January 19, 2024

**LINCOLN PUBLIC SCHOOLS
ARTS & HUMANITIES FOCUS PROGRAM – ENHANCEMENT PROJECT
LINCOLN, NEBRASKA**

ADDENDUM #1

10 OUTDOOR UNIT SUPPORT FRAME DETAIL
M2.1 NTS

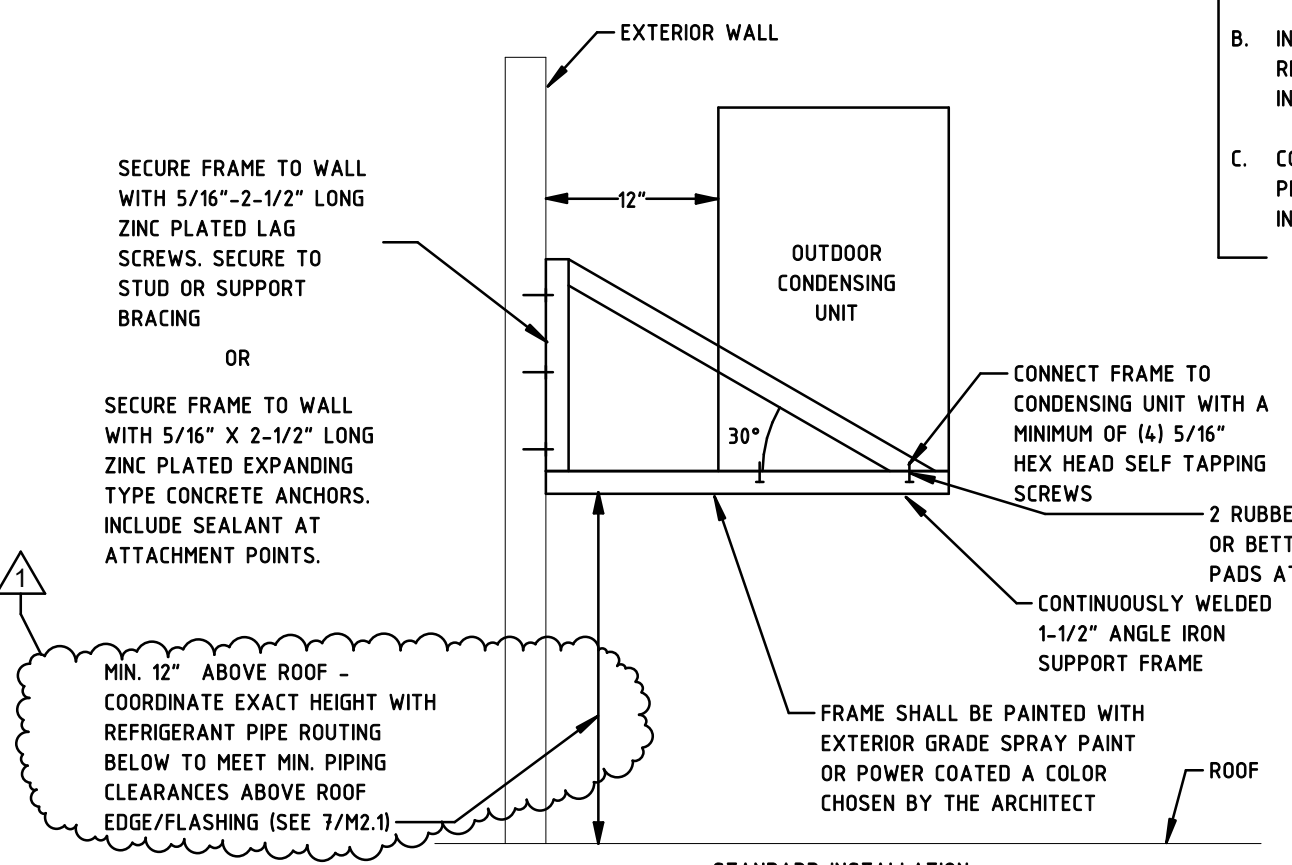
- A. D8 – KILN VENTILATION DETAIL
 - Added minimum dimension (5'-0" AFF) for mounting height of kiln ventilation blower motor.
- B. D10 – OUTDOOR UNIT SUPPORT FRAME DETAIL
 - Revised wording of support frame mounting height to read "MIN. 12" ABOVE ROOF – COORDINATE EXACT HEIGHT WITH REFRIGERANT PIPING BELOW TO MEET MIN. PIPING CLEARANCES ABOVE ROOF EDGE/FLASHING (SEE 7/M2.1)."

2 OVERALL MAIN FLOOR PLAN - ELECTRICAL NEW
E1.0 1/16" = 1'-0"

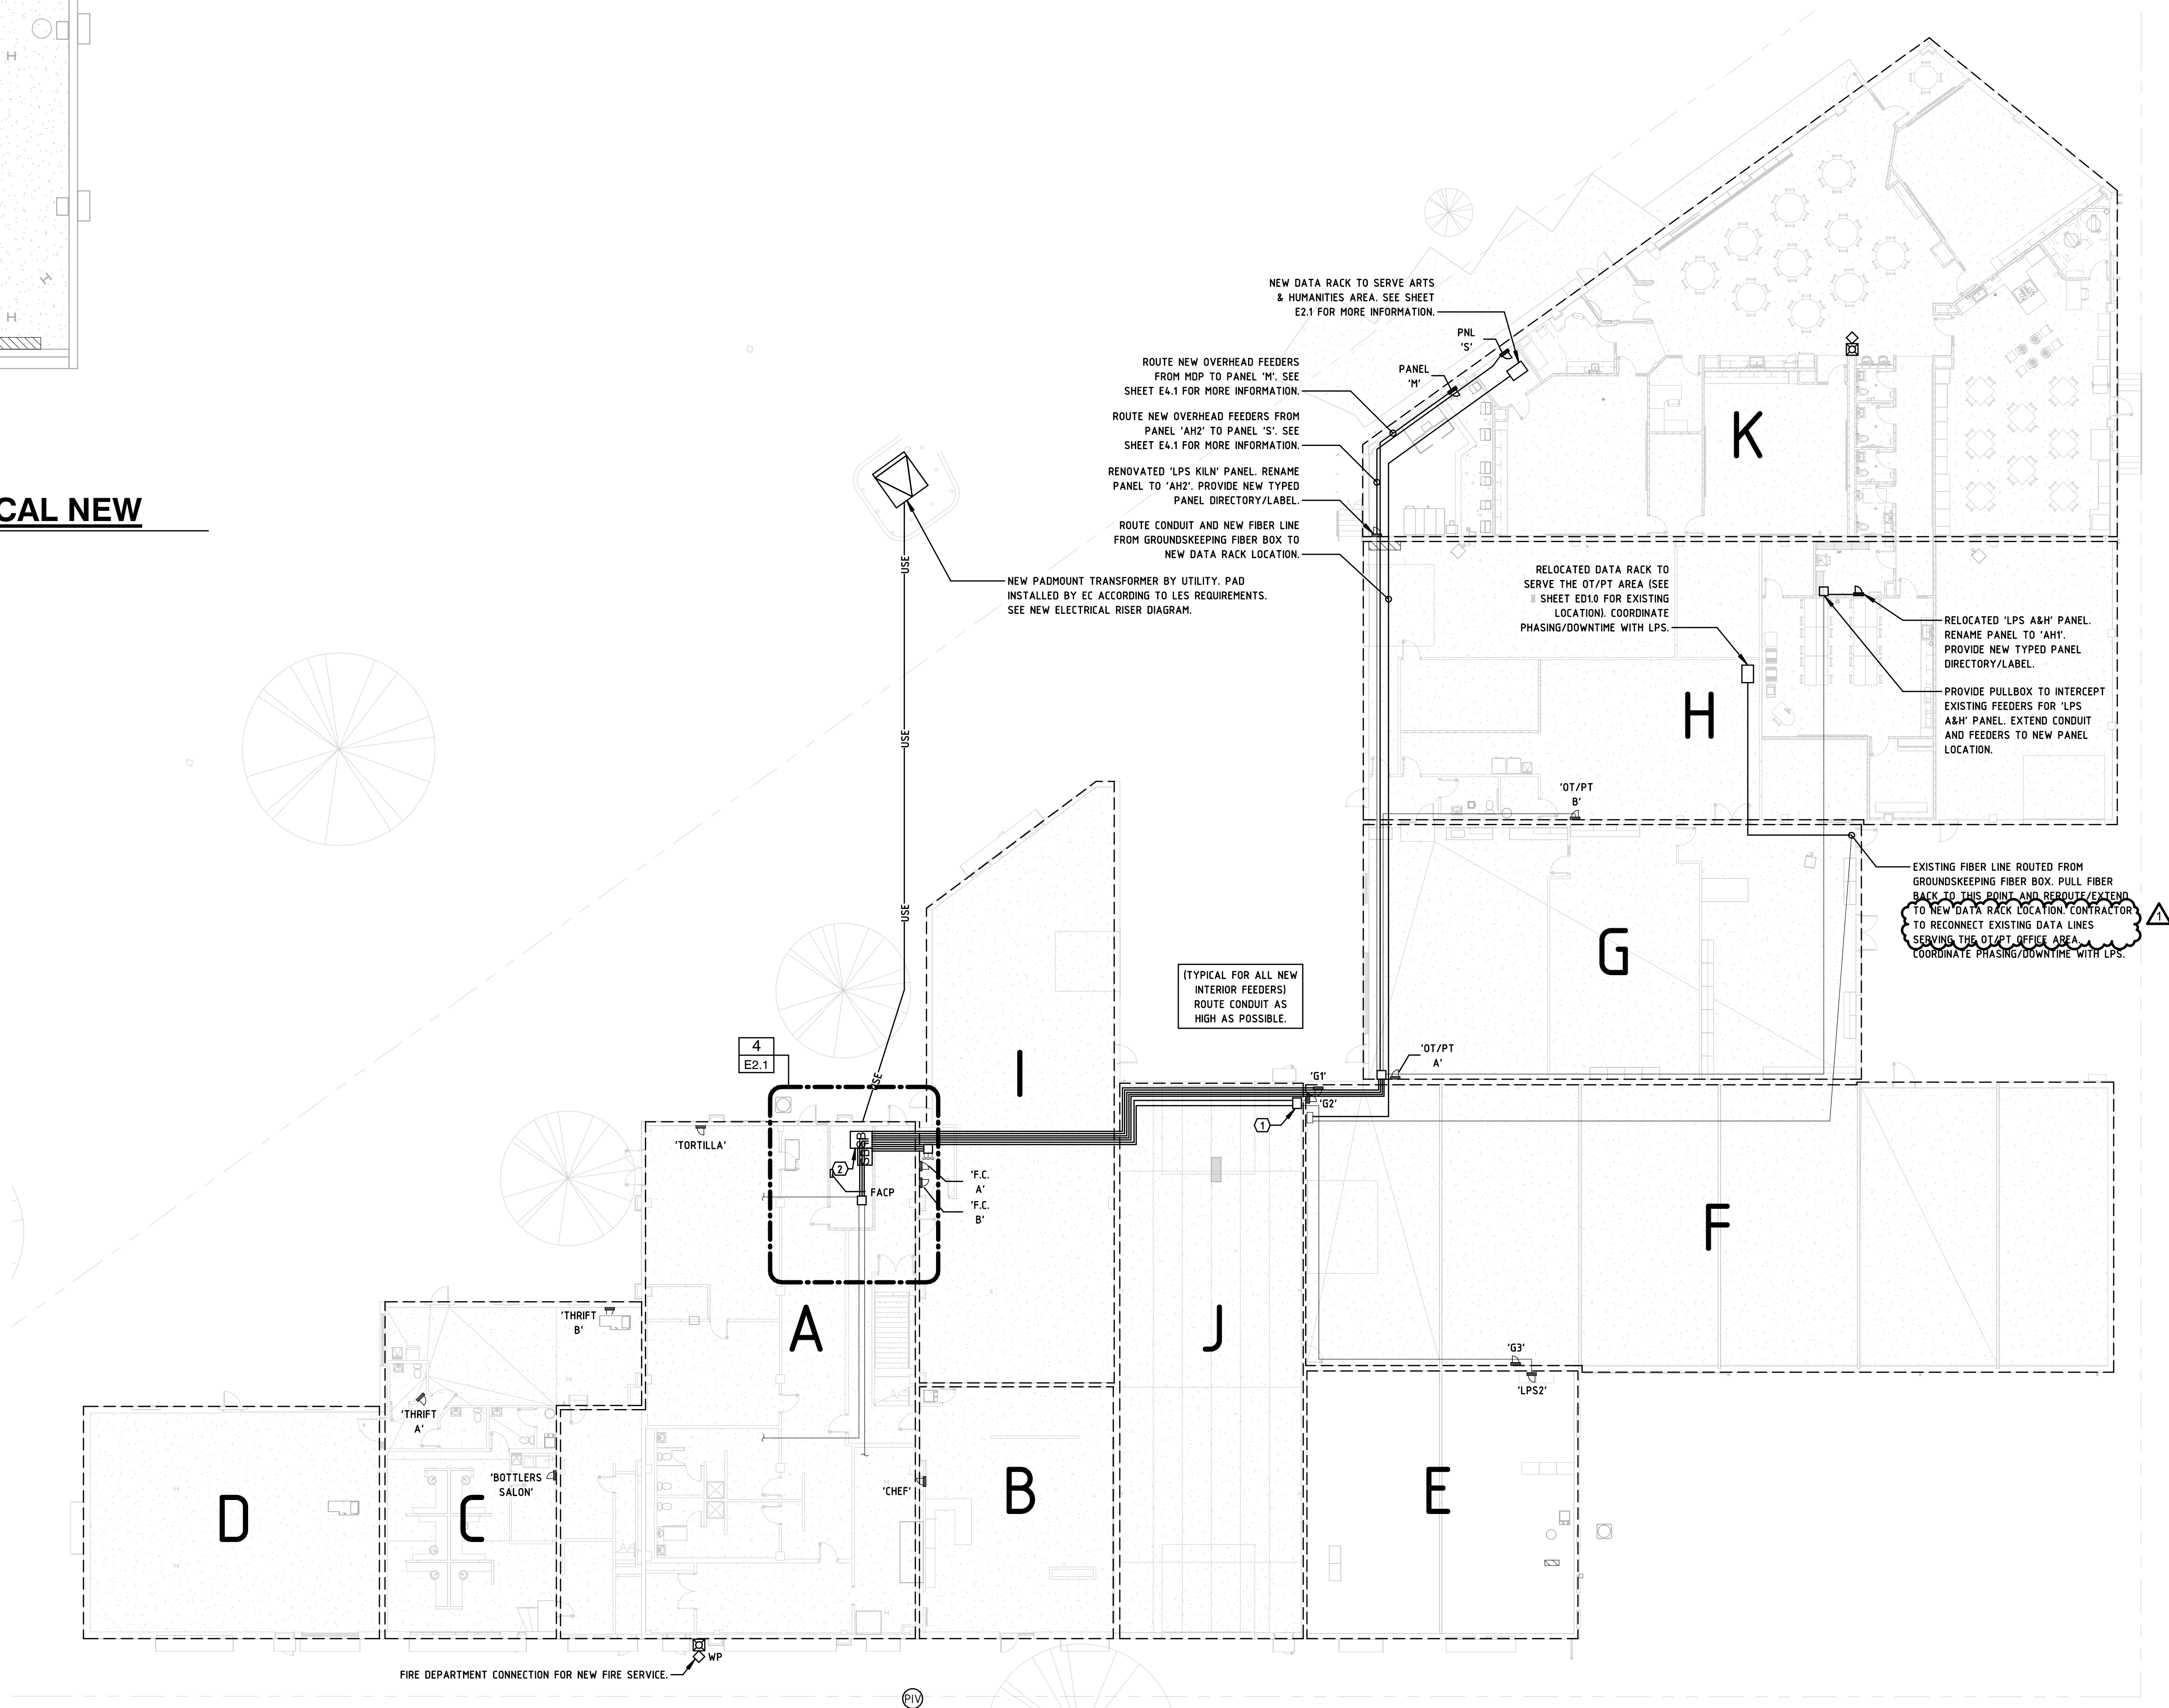
3. E1.0 – OVERALL BUILDING NEW – ELEC. EQUIPMENT PLANS – LOWER & MAIN LEVELS

- C. OVERALL MAIN FLOOR PLAN – ELECTRICAL NEW
 - Added 'Contractor to reconnect existing data lines serving OT/PT office area'.
